PEPPER

500cc

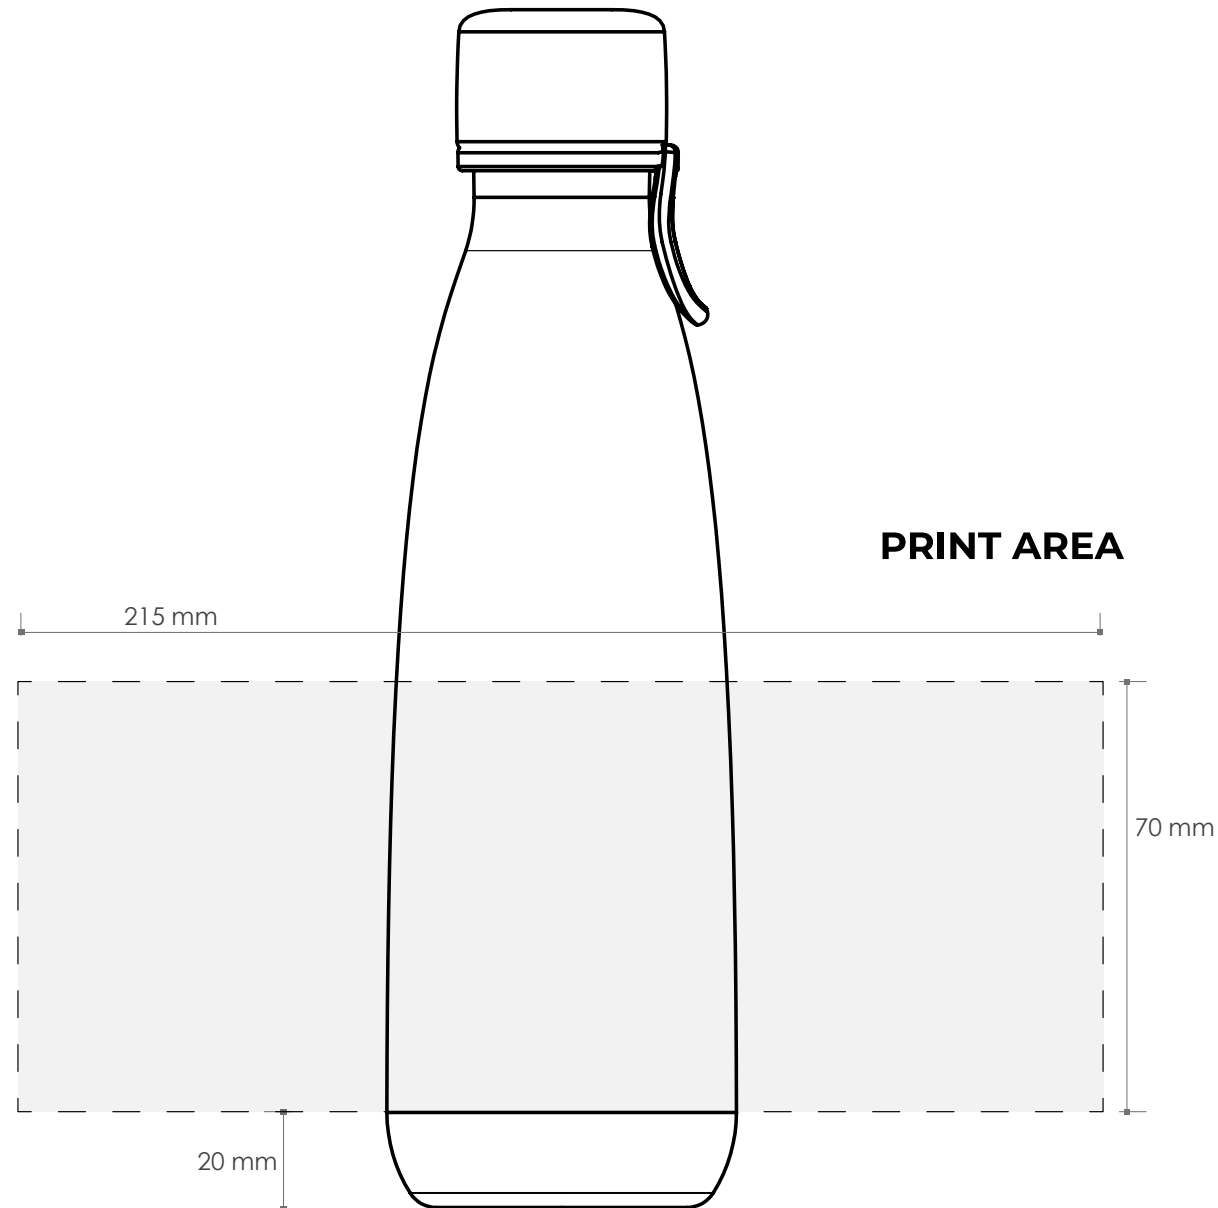
The impression can not close on the circumference of the bottle:
it's necessary to consider a non -printable area (approx. 0,8 cm width)
